THE HASKELL COMPANY
NASSAU COUNTY COURTHOUSE
65198712-562220
65000000-205509

Change Order Request

Nassau County Courthouse Facility
24100 William Burgess Blvd.
Yulee, Florida

Change Order Request: 05

PROPOSED LOADING DOCK
RECEIVING & FIBER NODE ROOM

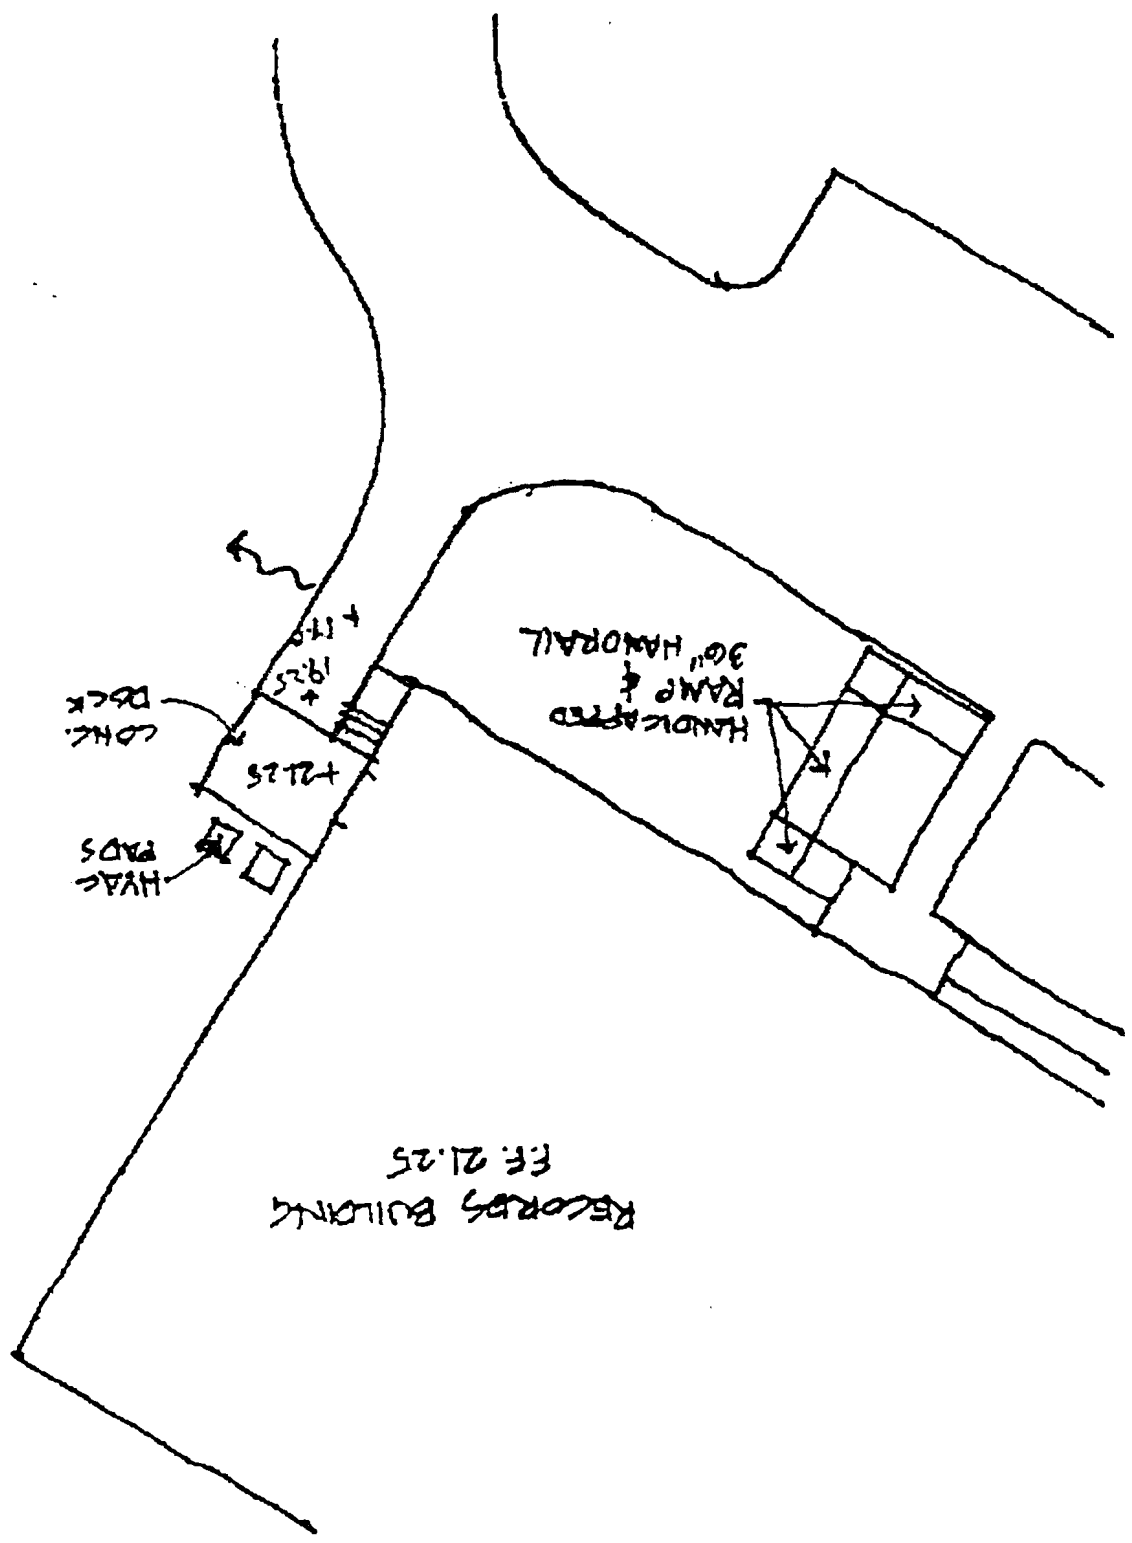
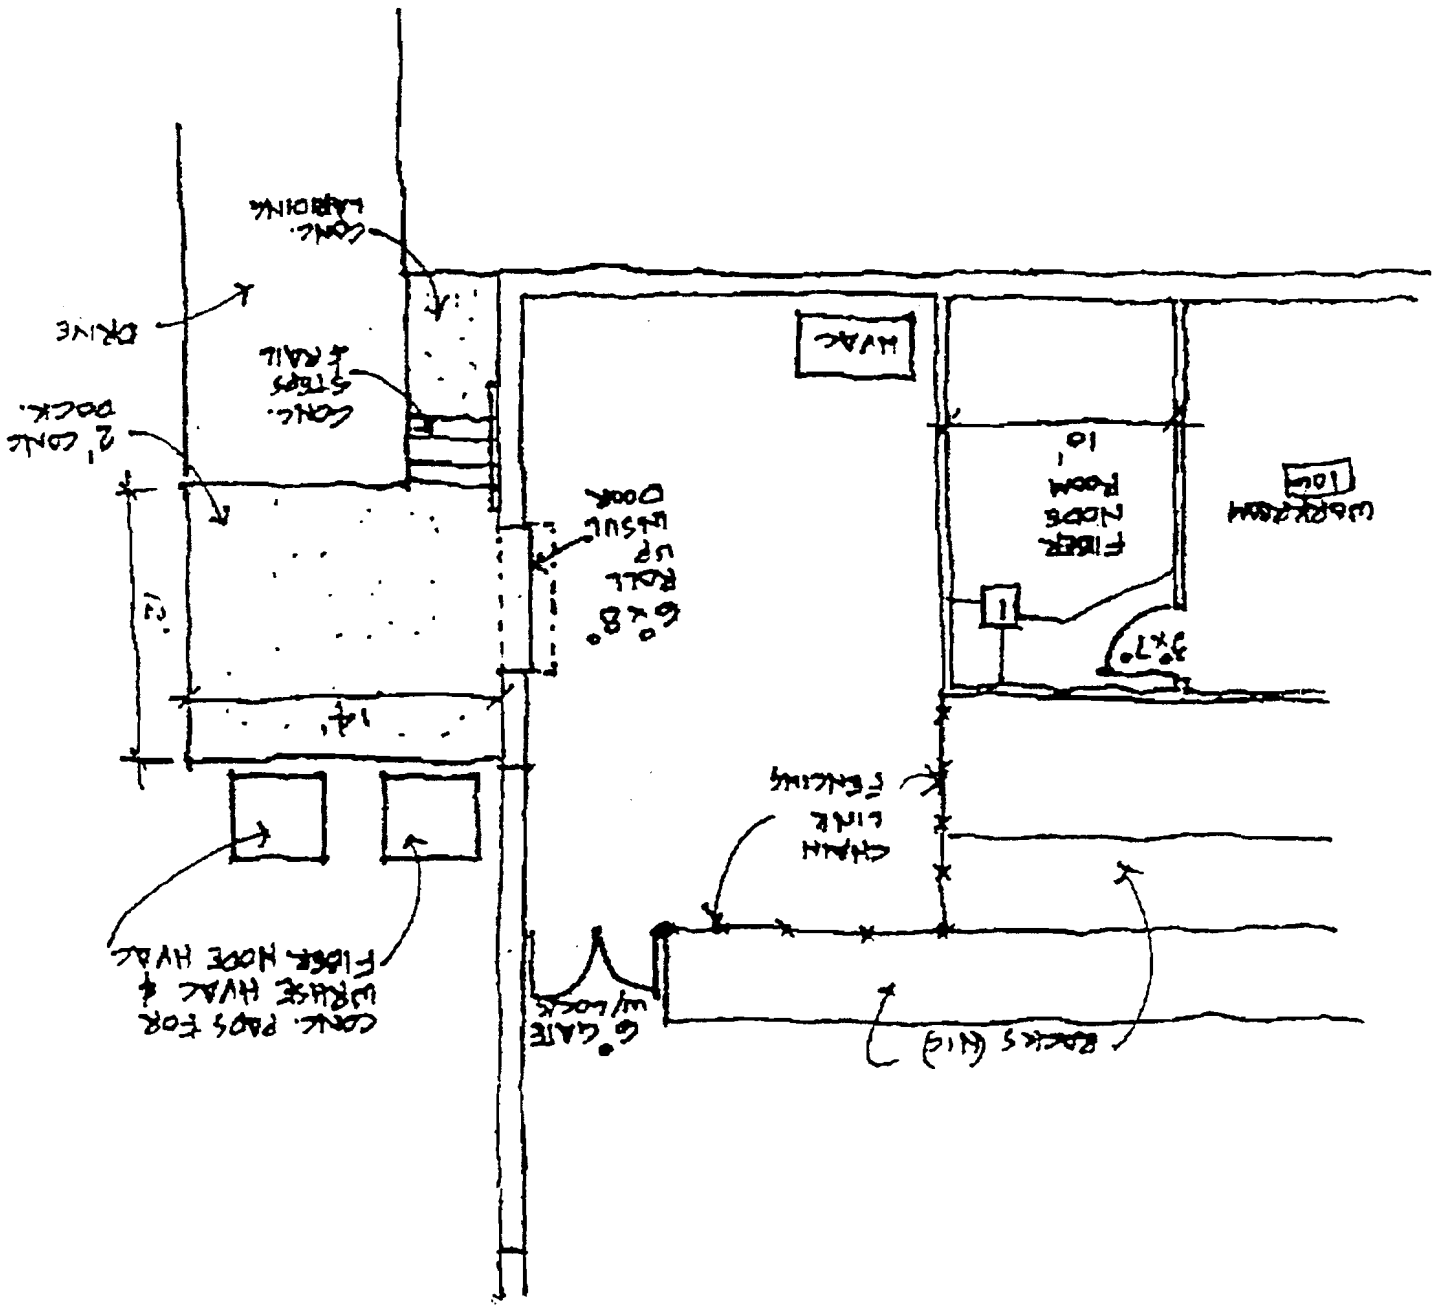
Description	Category	Status
Fiber Node Room & Loading Dock

PCO No	Date	Reference	Amt Prop	Days Req	Category	Reason
03	11/6/2002		\$ 78,777	21	Change Order	Owner Change
Addition of Loading Dock & Node Room			Scope includes adding Node Room, Additional Electrical Circuits, Conduits to Courthouse, HVAC Unit, Fencing for Receiving Area, Roll-Up Door, Electrical Fixtures, Loading Dock, Handrails, Ramps & Walls and Dock Bumpers.

Misc. Notes : Based on the following
Sketch provided. Information for Liebert Vendor for leader sizing.
Fiber Node Rm to have drop in ceiling with 4 type A fixtures.
